P 528425

**ON-SITE SEWAGE DISPOSAL SYSTEM
HOWARD COUNTY HEALTH DEPARTMENT
BUREAU OF ENVIRONMENTAL HEALTH**

SUBDIVISION: Cloverfield

ADDRESS: 13512 Mitchell's Way

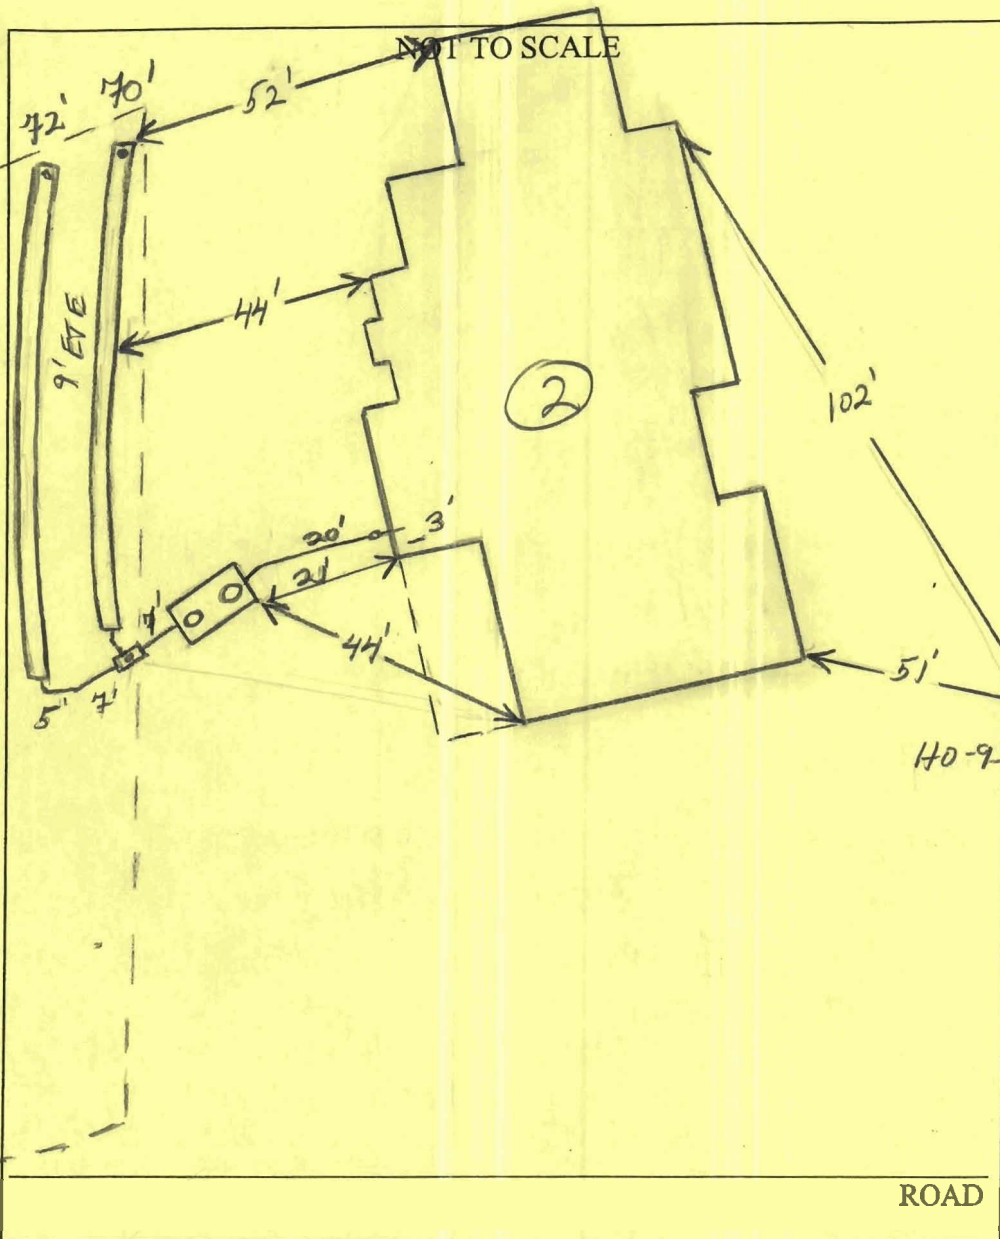
PRE-CONSTRUCTION 1/8/08 Keep tank 20' from house. Install 2x70' trenches on contour towards right lot line left side of current

INSTALLATION contour did not match building permit plans (KW)

1/9/08 Tank & D box set. Horse connection made. Top trench dry. No stone. Bottom of trench was tamped. Told contractor to rake bottom of trenches w/ back hoe. OK to continue (KW)

1/10/08 System complete per installation. D box installed w/ levelless. OK to cover. (KW)
